National Standards for Traffic Control
Devices; Revision of the Manual on
Uniform Traffic Control Devices; Final
Rule

[FHWA Docket 95-8]

National Standards for Traffic Control Devices; Revision of the Manual on Uniform Traffic Control Devices**AGENCY:** Federal Highway Administration (FHWA), DOT.**ACTION:** Final Amendments to the Manual on Uniform Traffic Control Devices (MUTCD).

R10-3b
225 mm x 300 mm
(9" x 12")

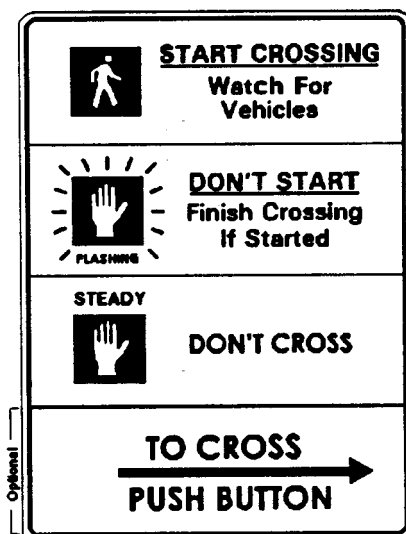
Request IV-124(C)—Educational Plaque for Pedestrian Signals

This amendment will allow the use of an educational plaque that can be used in conjunction with pedestrian signal indications. The FHWA is adopting the use of this optional educational plaque where both symbol-type and word message pedestrian signal indications are used.

A total of 27 of the 30 comments received agreed with the use of the educational plaque. The wording of the plaque shown in the notice of proposed rulemaking has been slightly modified to reflect the following comments:

1. After the wording DONT START use FINISH CROSSING IF STARTED.

2. Pedestrians should be aware of all vehicles, not just turning cars.

3. The highlighted flashing hand symbol is more easily understood.

4. All intersections do not have marked crosswalks.

5. Eliminate the wording WAIT ON CURB because all intersections do not have curbs.

6. Many intersections in the United States do not have push buttons for operating signals and, therefore, the bottom section of the sign with the caption "TO CROSS. . . PUSH BUTTON" should be made optional.

7. Since both symbols and word messages are allowed for pedestrian signal indications, two plaque designs are necessary.

Note: Word message (R10-3c) may be used in place of WALK/DON'T WALK symbol.
